Service Bulletin

Bulletin No.: 20-NA-198

Subject: Trailer Running Lights Shut Off Due to Excessive Load on the Running Lamp Circuit

Brand:	Model:	Model Year:		VIN:		Engine:	Transmission:
		from	to	from	to		
Chevrolet	Silverado 1500 (New Model)	2019	2019			All	All
GMC	Sierra 1500 (New Model)

5209978

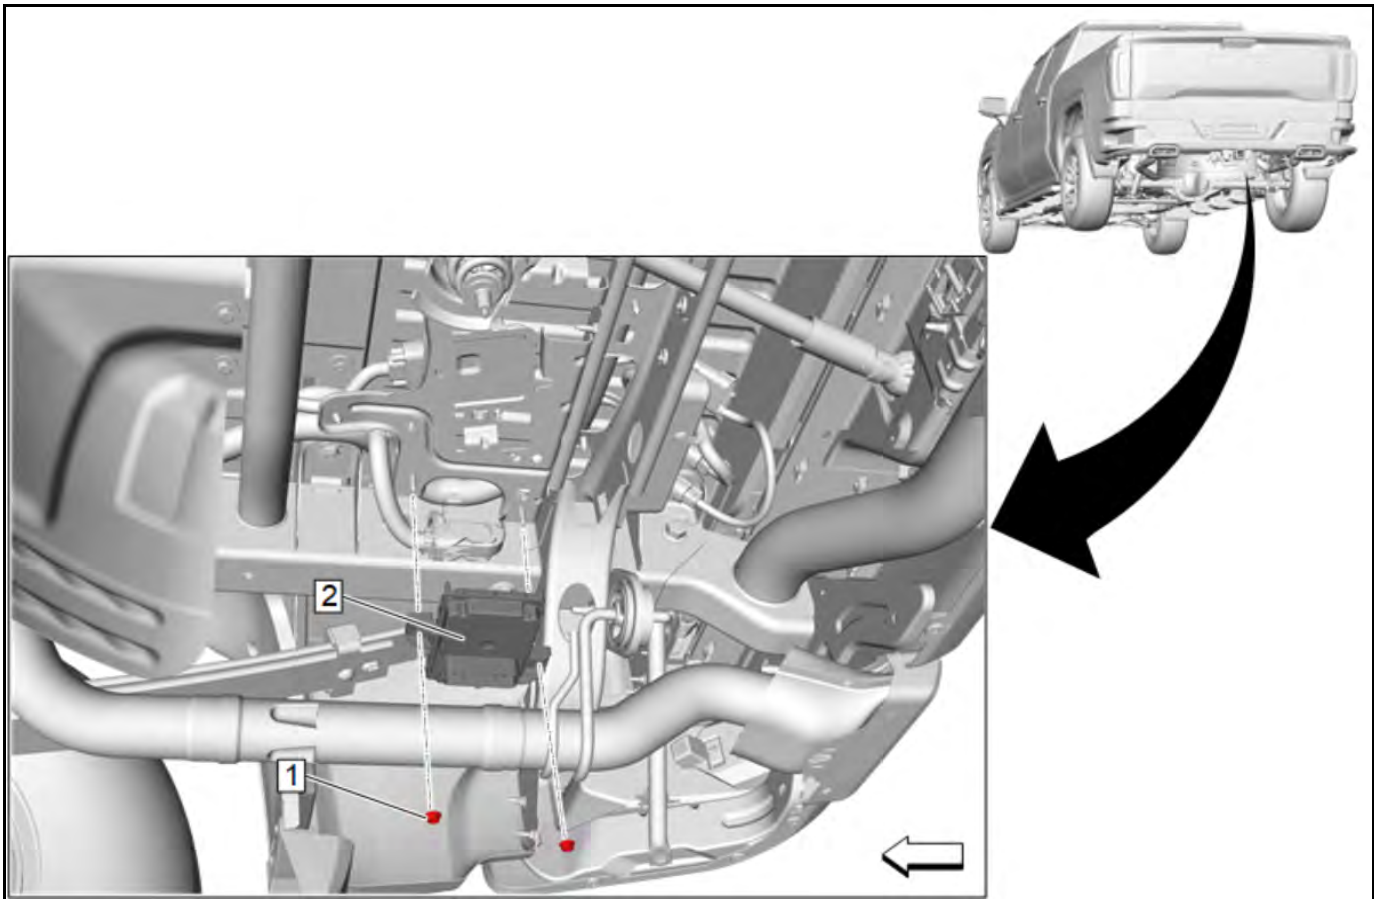
3. Locate the Trailer Lamp Control Module (2) and disconnect the chassis harness X1 electrical connector.

5652572

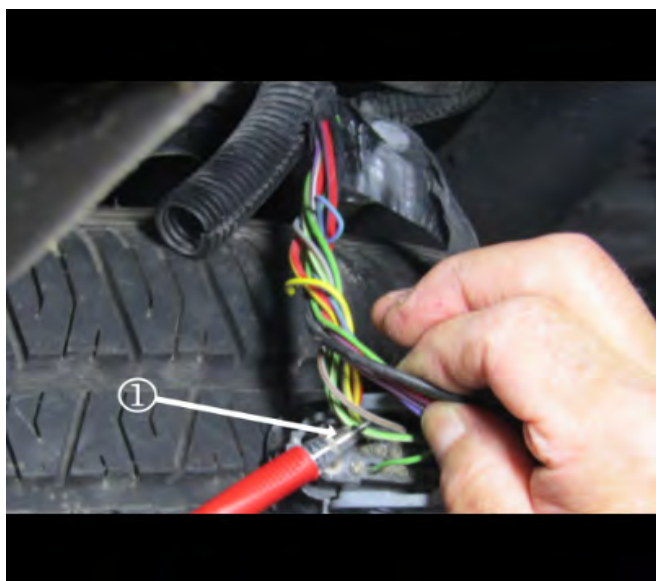
4. Cut off the tie strap retaining the wiring harness and remove the cover from the connector.

5652578

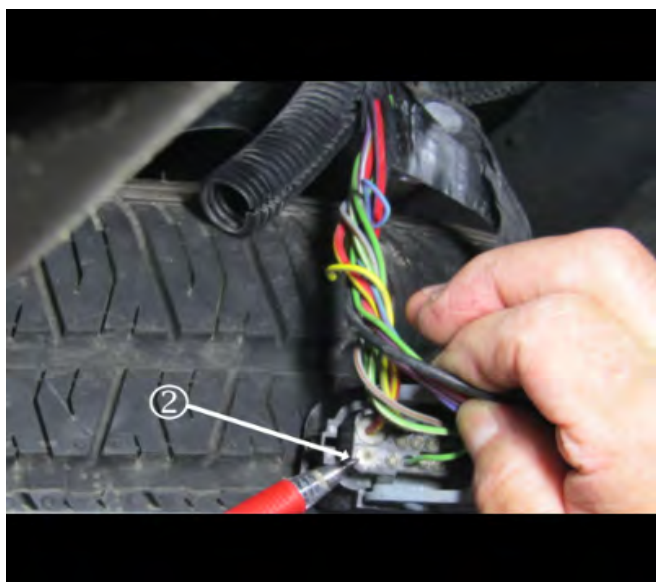
6. Locate the Gray/Brown wire, at pointer (1), connected to cavity 5, and cut the wire approximately 7.62 cm (3.0 in) from the connector body. The wire will be re-located to cavity 25 (2).

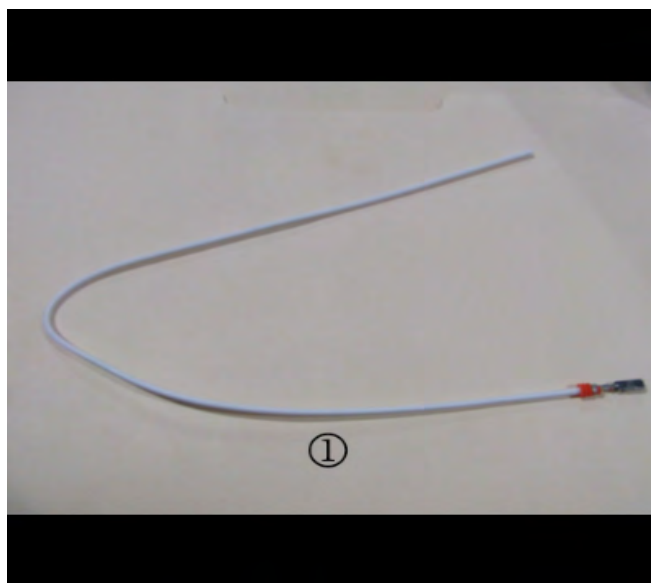
7. Release the 4 tabs on the Terminal Position Assurance (TPA) and pull slightly upward to partially release it from the connector housing.

5652580

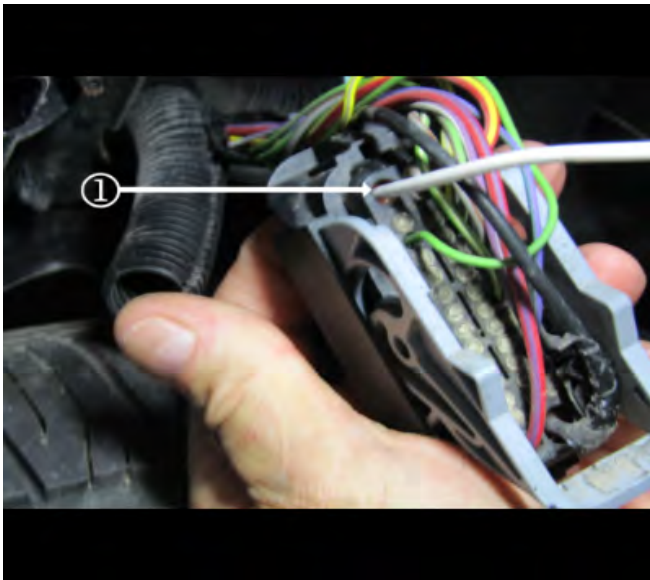
8. Remove the seal from connector cavity 25 and install the new terminated lead (1) into this cavity. Ensure the terminal locks into place by pulling back gently on the wire.
